CITY OF ALBUQUERQUE

**Re: Lot 25-A, Block J, Lavaland Addition
Request Permanent C.O. - Accepted
Engineer's Stamp dated: 8-4-13 (K12D082)
Certification dated: 9-25-14**

RE: LOT 26-A, BLOCK J, LAVALAND ADDITION
FINAL CERTIFICATE OF OCCUPANCY (K-11/D082)

Re: **Lot 26-A, Block J, Lavaland Addition**
Grading and Drainage Plan for Building Permit

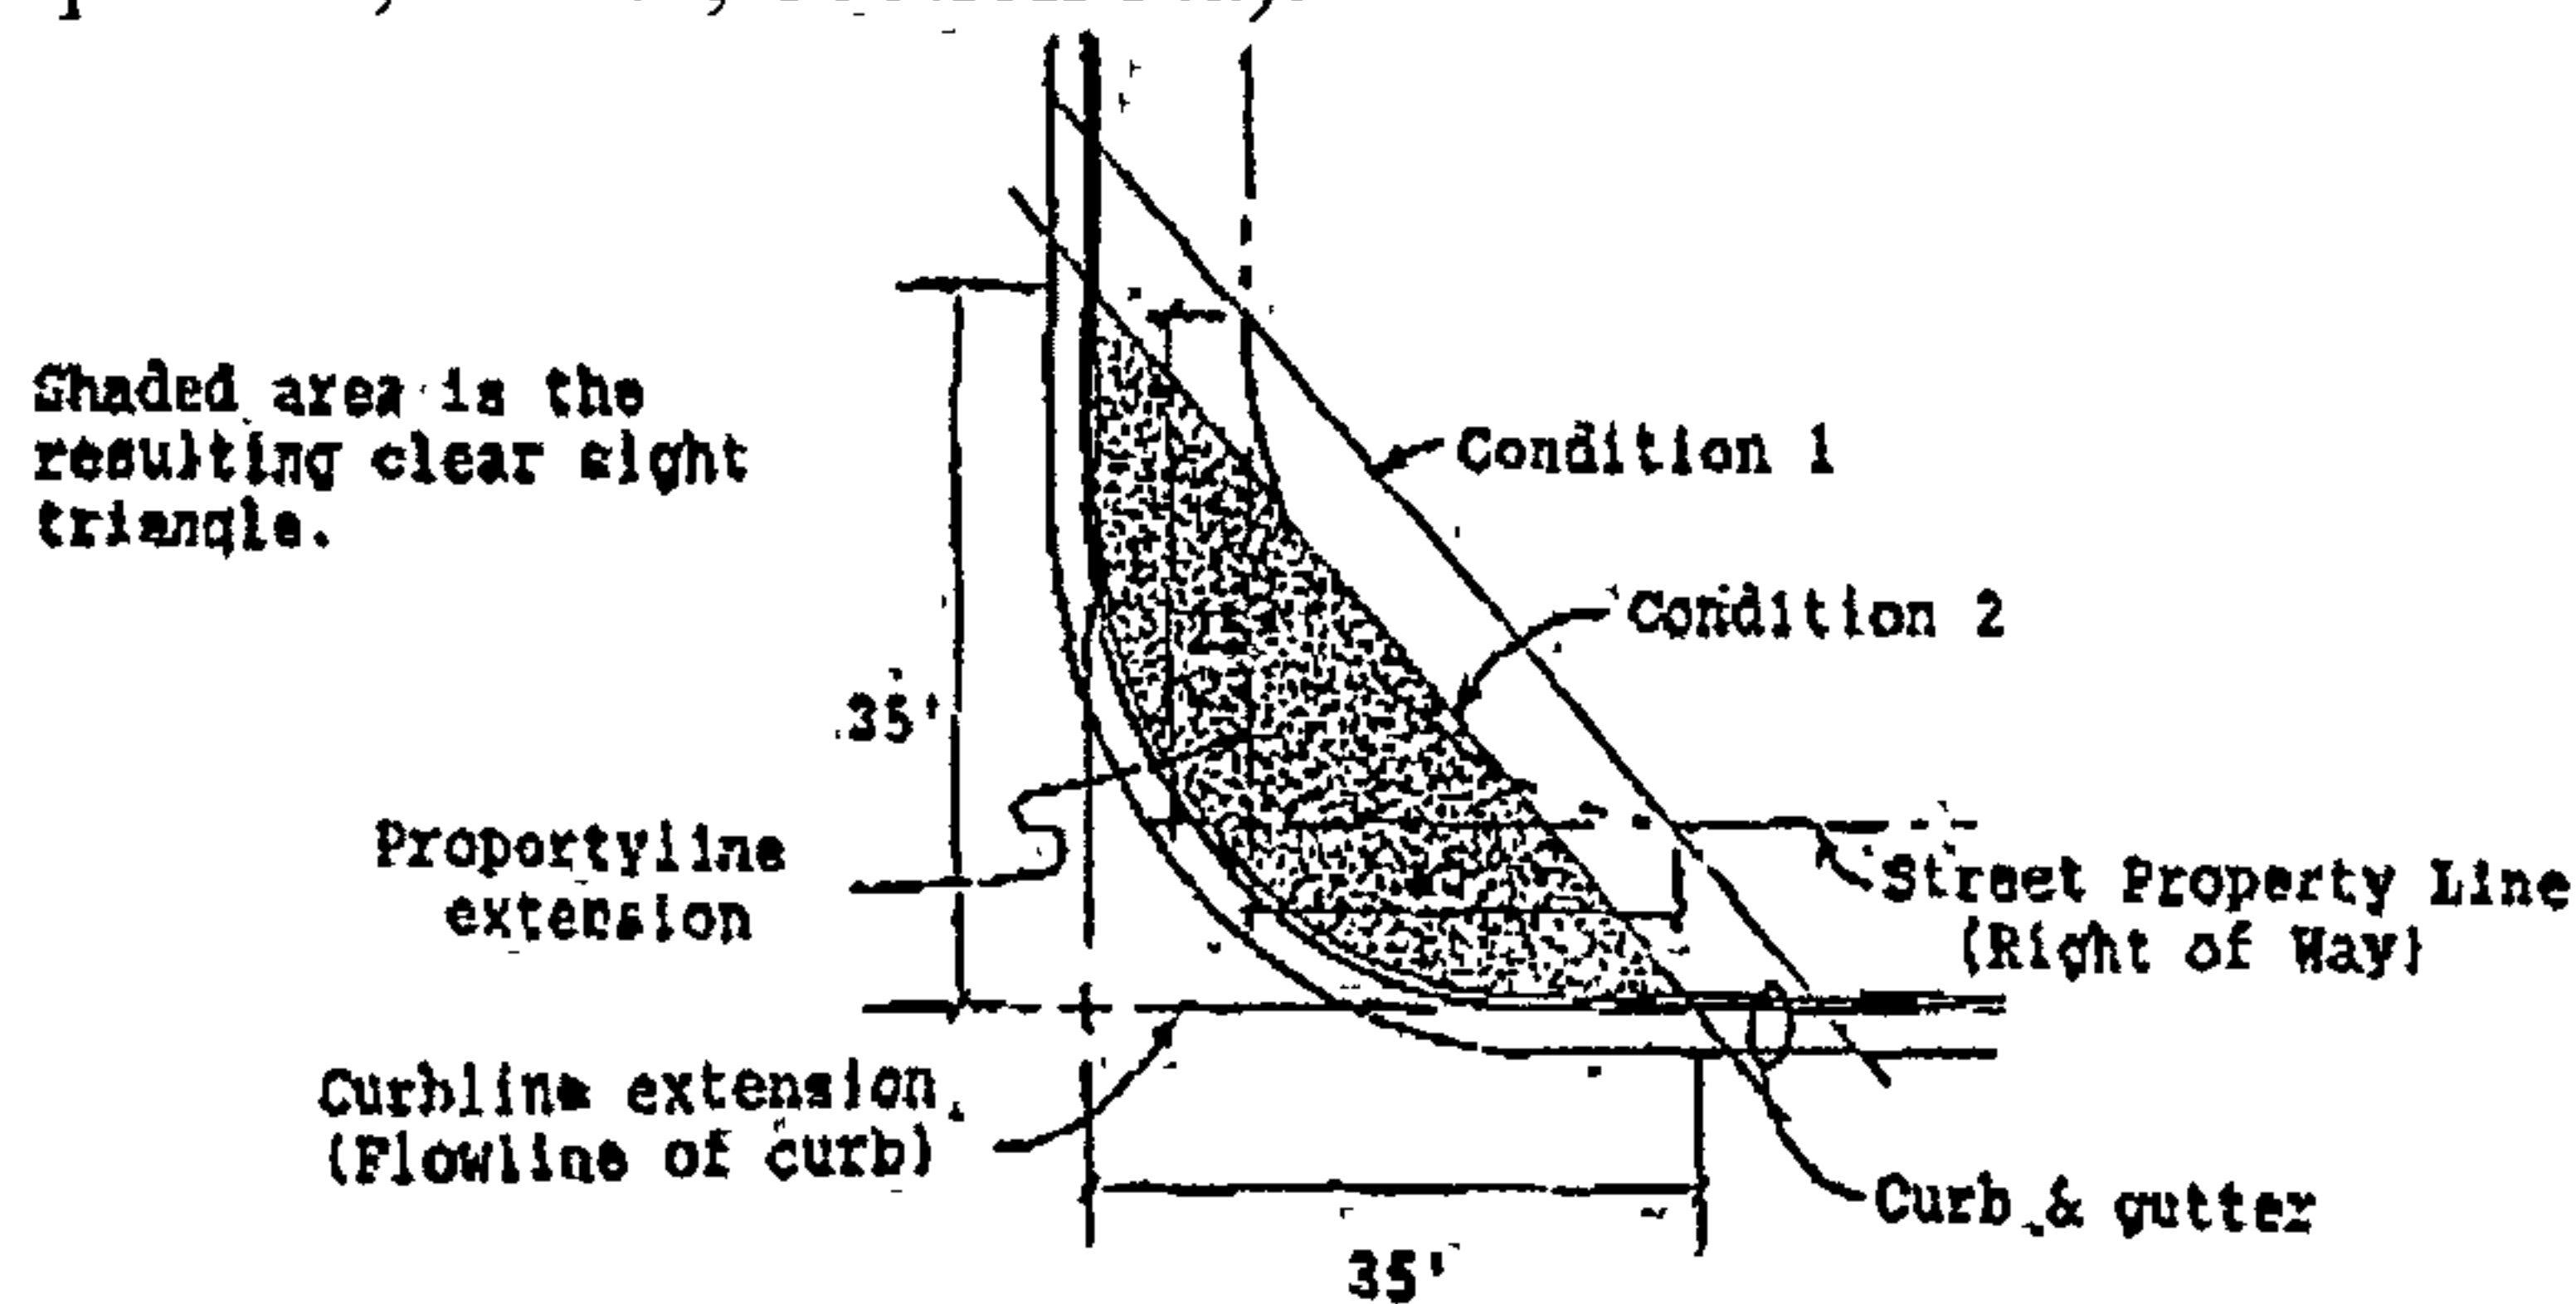
1. Please include two copies of the traffic circulation layout at the next submittal.
2. List radii for all curb returns associated with drive pads; for passenger vehicles, the minimum radius is 15 feet.

3. Please label and dimension proposed curbing. Curbing should be used to separate landscaping from parking areas and pedestrian ways.
4. Keyed Note #9 is not used.

5. Please provide posted signage for motorcycle stall.
6. Please refer to all applicable city standards.
7. Please ensure all ramps are ADA compliant.
8. Please clarify keyed note #10 pedestrian access way: Pavement striping? Asphalt surface? Elevation difference between public sidewalk and parking area? ADA ramps? Header curb cuts? Please provide details.

9. Show a detail of the wheelchair ramps located at the proposed driveway, or refer to the appropriate city standard.
10. List the width of the existing drive pad to remain. Please note the drive pad keyed note #5 refers to an "entrance" but the site layout indicates it functions as an exit only.

11. Please add an additional "Do Not Enter" sign at the one way exit, providing signage on both ends of the driveway: The signs must be placed within the property.

12. The existing drive pad on 65th must be reduced to accommodate the drive aisle and the refuse width only. Please reconfigure curb cut.
13. Has Lee Whistle, COA refuse, approved the location of the dumpster enclosure?
14. The existing sign, keyed note #18, can not overhang into the COA ROW airspace without a Revocable Encroachment Permit.
15. The proposed landscape area may interfere with the sight distance of the intersection. Please add the following note: "Landscaping and signing will not interfere with clear sight requirements. Therefore, signs, walls, trees, and shrubbery between 3 and 8 feet tall (as measured from the gutter pan) will not be acceptable in this area." Please see sight distance exhibit at street intersections for clarification (the *Development Process Manual*, Chapter 23, Part B, Section 5.a).

1. Two copies are attached.
2. The curb returns with the drive pads have been modified and marked as requested.
3. As we discussed the curbing has been added to site plan.

4. Keyed Note #9 is marked on site plan and is existing curb & gutter.
5. The posted signage for motorcycle stall is provided.
6. Reference to all the applicable City Standards are shown.

7. All the ramps are ADA compliant and notes are added to site plan.
8. Keyed note #10 has been clarified and curbing is added on both site.
9. The detail is included in the reference drawing for the proposed driveway.

10. The Keyed note #5 has been modified to show existing entrance to existing exit and the width is included.
11. Additional "Do Not Enter" has been added and placed within property line.

12. The actual exit driveway is shown and as we discussed is sized for the trash bin and exit of the vehicles.
13. The Solid Waste Department is ok with location of the dumpster enclosure.

14. The existing sign is within the property and is not in the City Right of Way.
15. A note is added to the site plan.
